# HRI, Inc.

RE: Comments on Groundwater Velocity Calculations (12/15/95) at Crownpoint.

SUBJECT: CALCULATIONS OF GROUND WATER MOVEMENT, RELEVANT TO  
CROWNPOINT COMMENT 54

ANALYSIS OF HYDRODYNAMIC  
CONTROL, HRI, INC.  
CROWNPOINT AND CHURCHROCK  
NEW MEXICO URANIUM MINES

Attachment 4

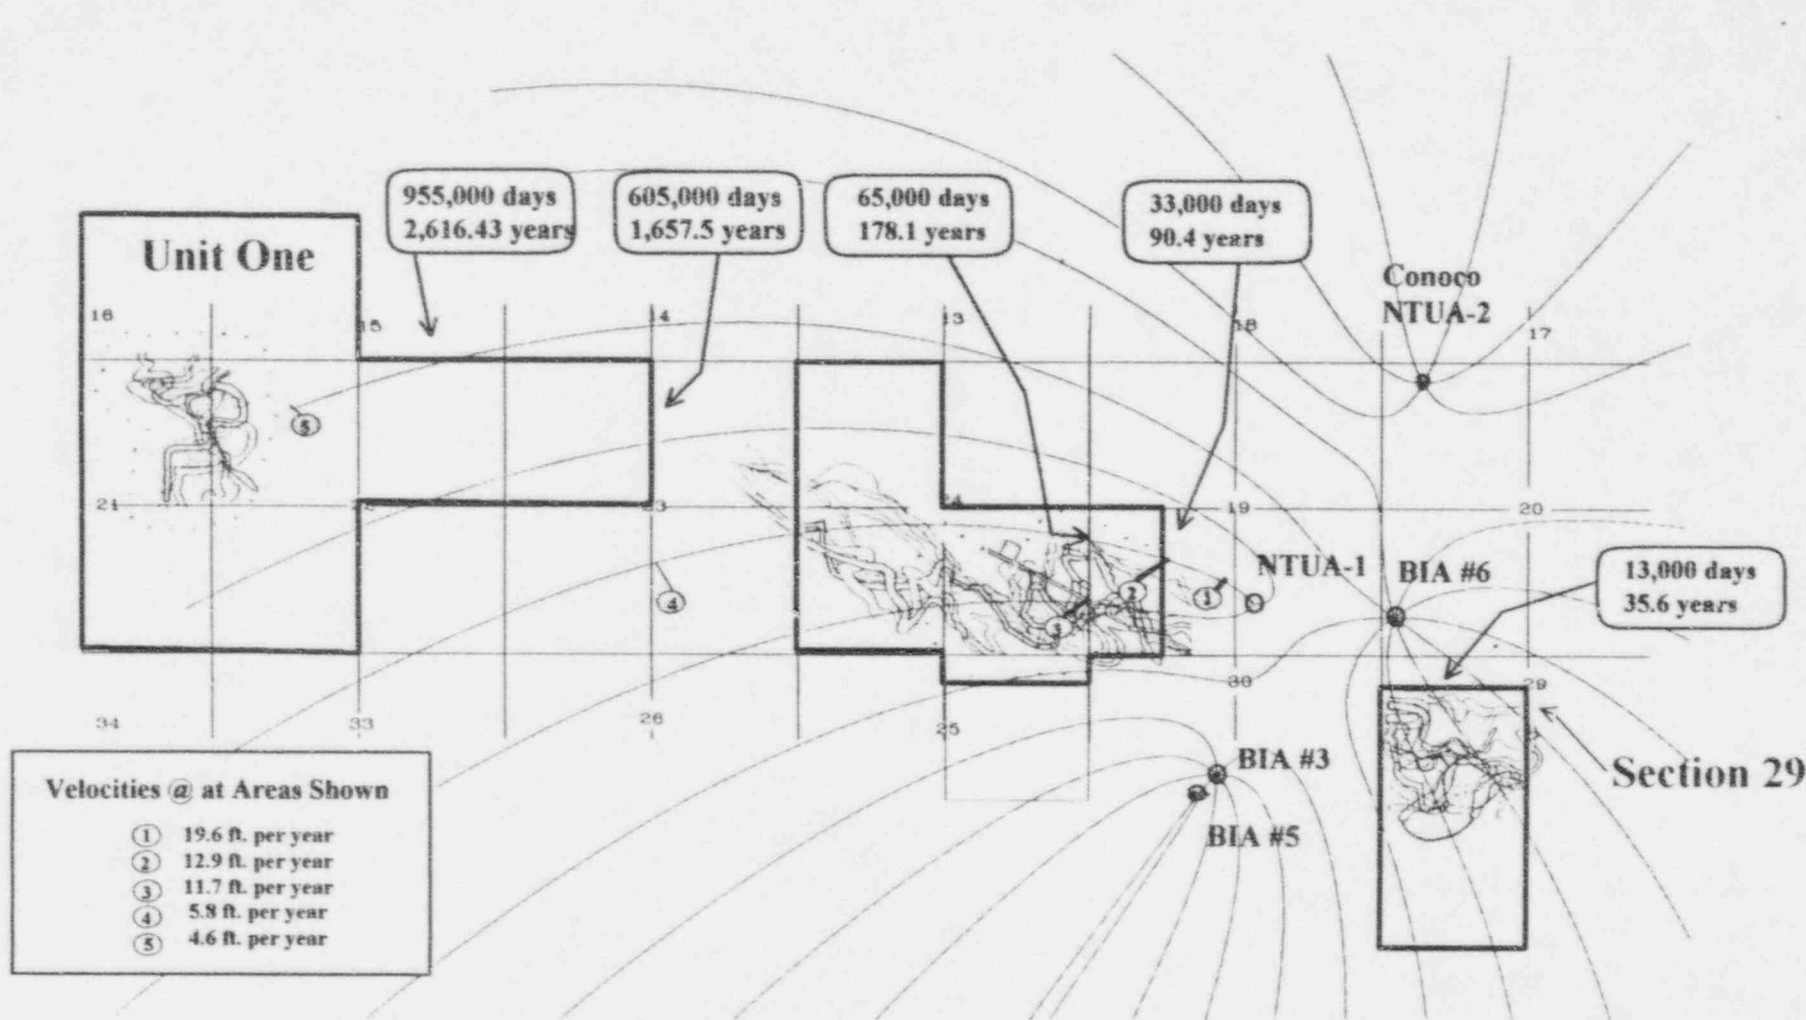
The pathline or particle tracking can also be done for the flow system depicted in Figure 8 by Geraghty & Miller [and this was done: Q1/50 (Attachment 50-2), here as Attachment 4 described above]. However, it is NOT valid to calculate the travel times from the "Ground Water Divide" of that Figure to the Town water wells for two reasons.

a) Since we are involved in a radial flow system, the monitor wells WILL detect any lixiviant excursion. It is not reasonable to consider that the ISL wellfields would be operated in the same fashion for YEARS after an excursion is detected, until the lixiviant is at, and then beyond, the "Ground Water Divide". The NRC license itself will require termination of lixiviant injection within 60 days (Section 8.7.2, Consolidated Operating Plan, Crownpoint Uranium Project) if an excursion is not corrected or recovered. This 60 days or 0.17 years is compared to the 90.4 years (Crownpoint) and 1,657 years (Unit 1) for the fluid movement to the nearest Town water well, as described above.

b) The "Ground Water Divide" in Figure 8 (Attachment 2) is 400-1000 feet BEYOND the monitor wells. Since water canNOT travel parallel to the pressure gradient, water on the monitor well side will not cross that divide. As we **increase** the wellfield bleed rate, the ground water divide moves out even FARTHER beyond the monitor well ring and toward the Town water wells. Much HIGHER ISL bleed rates can be used which will cause the ground water divide to move even closer to the Town water wells, say within 5-10 feet of one of the Town wells. In this case at these **higher** bleed rates, if we were to capriciously assume the scenario wherein an excursion will **somehow** move beyond the ground water divide, then the contaminated groundwater would move to the Town water wells almost instantaneously. This would lead us to the **erroneous** conclusion that the HIGHER wellfield bleed rates provide the LEAST protection for the Town water wells, while **lower** ISL bleed rates would provide the **greatest** protection. The best protection would then be at a bleed rate of zero, or even with overinjection, since that would move the ground water divide even further away from the Town water wells. This is NOT reasonable, and shows that the arbitrary assumption of groundwater contamination at the ground water divide is not justified.

The ISL bleed rates used in the groundwater model to develop Figure 8 were chosen to show that reasonable and easily attainable bleed rates would protect the Town water wells by causing the ground water divide to be **beyond** the monitor wells separating the proposed ISL wellfields and the Town wells. Obviously, even smaller bleed rates would accomplish this same objective.
